29 March 2023

Steve Findlay
Northern Beaches Council
725 Pittwater Road
DEE WHY NSW 2099

# Re: Request for additional information - 26 Ralston Road, Palm Beach - Mod2022/0518

Figure 2 - View from sitting position at western windows of second floor living area at 8 Ebor Road (as described/identified by Council) with red lines indicating the development as approved and the black lines indicating the modified proposal.

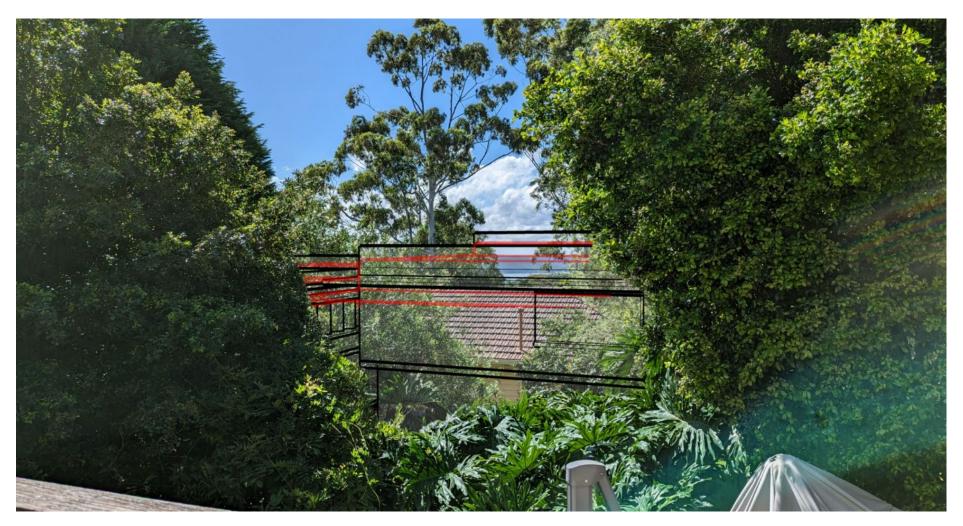
8 Ebor Road is located to the south and uphill of the subject site. The photos provided by Council indicate distant water views are obtained in a northerly direction from the second storey living area, the third floor study and the third floor bedroom. The views are obtained across the side boundary of 8 Ebor Road, are heavily filtered by vegetation and are highly vulnerable to future vegetation growth, including the extensive landscaping approved at the subject site in the original development consent.

Based on the height poles erected on site (**Annexure Two**), it appears that the proposed development will impact upon views from the second storey living room. However, as demonstrated, the view from this area was also lost as a consequence of the approved development, and in this respect, the impact remains the same as that originally approved.

The height poles also confirm that the views from the third floor will be wholly retained, with no additional impact arising as a consequence of the proposed modifications.
